TENTH EDITION HANDBOOK ERRATA

If you, as a user of the *IES Lighting Handbook*, 10th Edition, believe you have located an error not covered by the following revisions, you should e-mail your information to Pat McGillicuddy at: pmcgillicuddy@ies.org or send a letter to: Pat McGillicuddy, Manager of Technology, IES, 120 Wall Street, 17th Floor, New York, NY 10005. Additions will be posted to this list as they become available. This errata list was last updated on **November 23, 2015**. **Color headings indicate the latest postings.**

Page 2.6, Figure 2.5 Distribution of Rods and Cones in the Human Retina

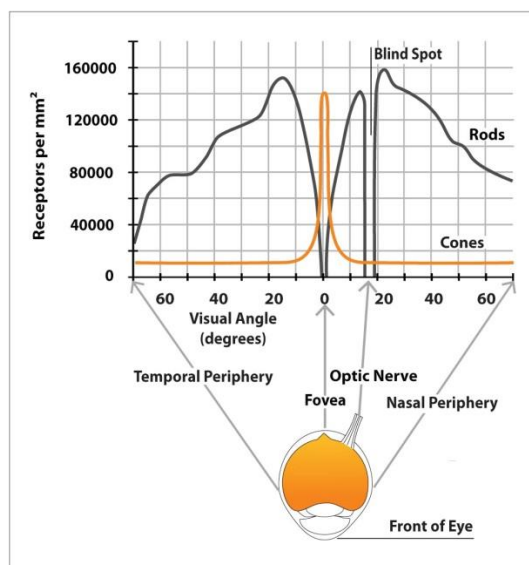
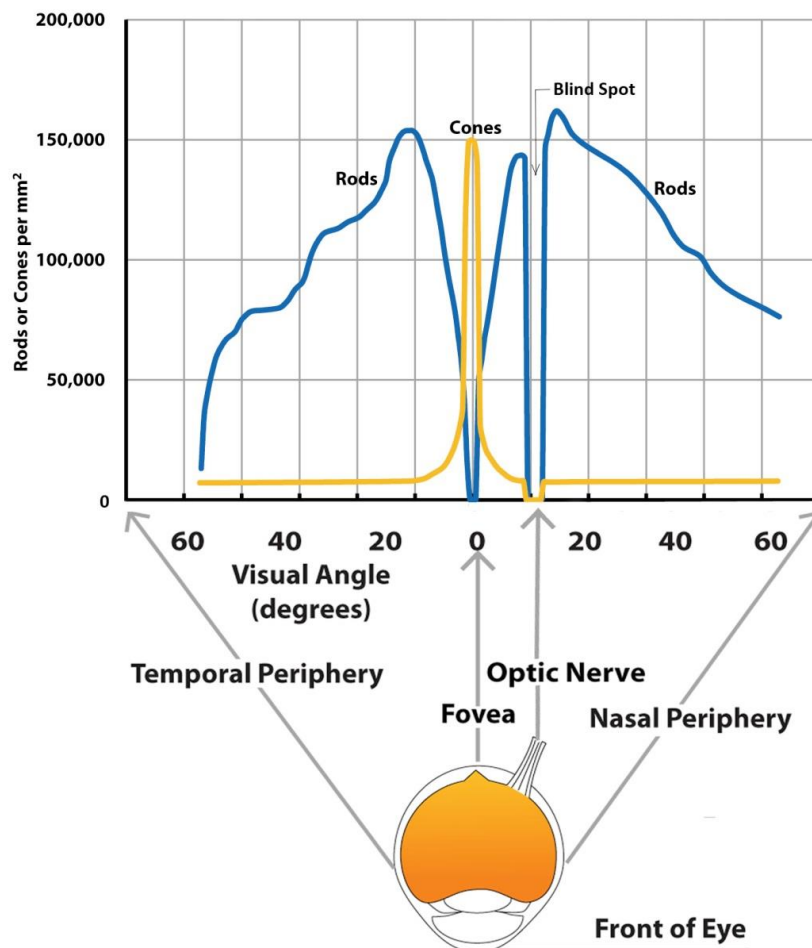
Replace the original Figure 2.5:

With this revised image, showing that there is no visual cone receptor response in the retina where the optic nerve exits the eye:
